ELAN Rev B3 Errata / Anomalies / Design Changes**Revised 07/17/95**

Errata numbers preceded with "E" are carried over from the ELAN Rev. A, those preceded with "EB" are new to the Rev B3.

#EB 26**PCMCIA Card Enables during SMI/NMI handlers in SUSPEND mode****REVISIONS
EFFECTED:**

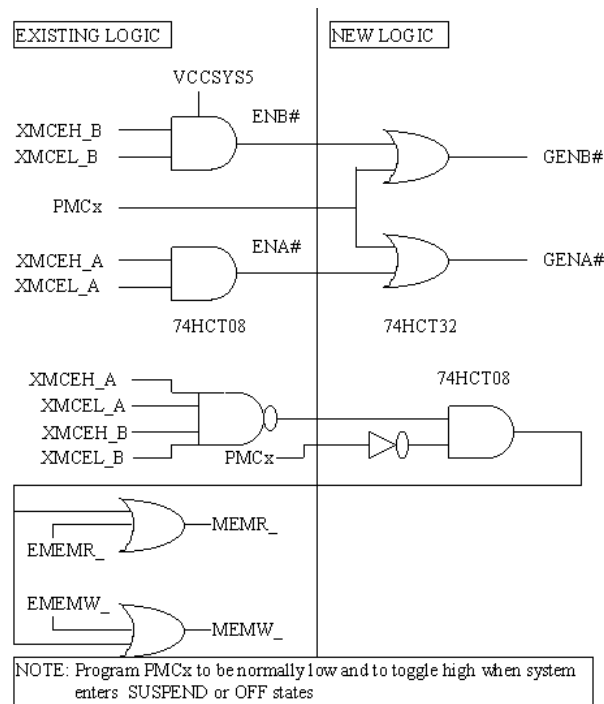
During a temporary-on SMI/NMI handler when the PMU is in the SUSPEND or OFF PMU state, the PCMCIA Card Enables: (XMCEL_A, XMCEH_A, XMCEL_B, and XMCEH_B) are driven to '0's. This will cause the PCMCIA cards to drive data onto the SD bus during read cycles.

The PCMCIA Card Enables will be driven low during temporary-on SMI/NMI handlers when the PMU is in SUSPEND or OFF mode. Unless the PCMCIA sockets' data drivers are disabled, this will cause data contention on the SD bus between the two PCMCIA sockets and any other decoded device during an ISA bus read. In addition, all write cycles that go to the ISA bus will cause data to be written into both PCMCIA sockets.

If the user desires to use temporary-on SMI/NMI handlers during SUSPEND or OFF mode AND the PCMCIA sockets will drive data onto the SD bus (i.e. their data bus drivers have not been powered off or disabled), the following H/W solution may be implemented:

Gate the PCMCIA Card Enables with a PMC line that is programmed to indicate that the PMU state SUSPEND has been reached. PMC Suspend state control functions are in registers 81h, ABh, and ACh. The gating function should disable the ELAN's PCMCIA Card Enables from causing the sockets to drive data onto the SD bus. In addition gate the inverted PMC line (programmed for SUSPEND) with the existing MEMR /MEMW lines which currently are gated off when any XMCEx line is asserted. The new logic will keep MEMR/MEMW asserted while in a temp SMI/NMI handler during SUSPEND or OFF mode. See pictorial below.

Note: this fix will disable PCMCIA accesses in SUSPEND and OFF modes.

#EB 27**ISA Bus Conflicts during Fast ROM accesses**

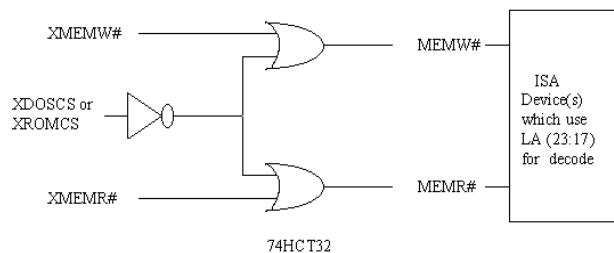
When the ELAN Rev. B is configured in the FULLISA pin-mode and ROM accesses are configured to run at the Fast CPU clock rate, the BALE (LVDD pin) output will not be asserted for FAST ROM accesses. If the last ISA cycle that asserted BALE is decoded by an ISA device that uses LA(23:17) in its decode, that device will conflict with FAST ROM accesses until BALE is reasserted.

ISA bus conflicts will be seen during FAST ROM cycles after an ISA device that uses LA(23:17) has been accessed.

Externally 'OR' the ISA memory commands (XMEMR and XMEMW) with the inverted version of the ROM chip select(s) (XROMCS and/or XDOSCS) that are enabled to run at the Fast CPU clock rate. The outputs of the 'OR' gates would then be routed to all ISA devices that use LA(23:17) to decode accesses. In addition, the XROMCS and XDOSCS outputs that will be used for FAST ROM accesses should be configured as address decodes and not internally qualified with the memory commands. This is programmable via Index B3H bit 2 (XROMCS) and Index B8H bit 4 (XDOSCS). See pictorial below.

#EB37**RESUME Event May Cause System Hang**

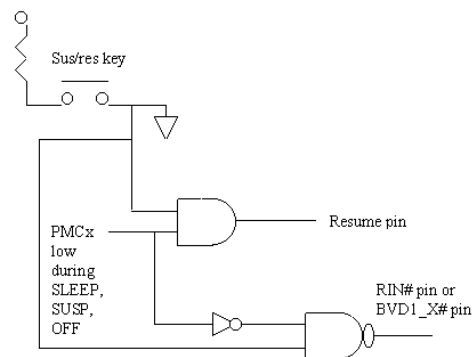
If the PMU receives a temporary-on event while the Low Speed PLL (LSPLL) is shut down and the PMU is in SLEEP, SUSPEND, or OFF mode, and a RESUME key press is received during the 256ms PLL startup interval (as defined by Index 8FH bits 2-0), the RESUME event will force the PLL startup timer to be reset causing the internal clocks to remain shut off. Since the internal clocks remain gated off, the system will hang. When this condition occurs, the system may be restarted by forcing XBL4 or XBL2 low while ACIN is low and the appropriate bit is set in Index 74H bits 6 or 7.

RESUME events generated by the SUS/RES key may cause system hangs when temporary-on SMI/NMIs are enabled in SLEEP, SUSPEND, or OFF modes.

Gate Off the SUS/RES switch signal from the Resume pin on the ELAN using a PMC or PGP signal, such that the RESUME function is disabled while the PMU is in SLEEP, SUSPEND, or OFF modes. Also Gate the SUS/RES switch signal to an unused wake-up pin, such as RIN#, BVD1_X#, etc, to effectively act as the Resume signal to wake-up the system.

Since gating off the SUS/RES pin eliminates the ability to generate a Resume SMI, the following SW implementation is suggested if this functionality is necessary. Enable a DOZE to SLEEP transition SMI /NMI (will catch SUSPEND action of SUS/RES switch, BL2 and BL4). Once in the SMI routine, read the NMI/SMI control reg A5h, if bit 2 is set (DOZE to SLEEP transition) power down appropriate devices, write 0 to reg A5h (allow transition to SLEEP), then jump into a SW loop polling on PMU mode/and or Status bits (polling will halt once SLEEP mode is reached and the CPUCLK is halted). When an activity, wake-up, SUS/RES key press (via RIN or BVD1_X), or Temp on event (BL1, BL3, or PMU state transition) is received, the loop will resume, powered down devices can be re-enabled and the SMI/NMI handler exited when the polling loop detects FULL-ON mode. If the event warrants staying in a clock OFF mode - SLEEP, or transitioning to a lower PMU mode (SUSPEND or OFF) than clear NMI/SMI via reg A2H write, do appropriate tasks and remain in the SW loop. See pictorial below:
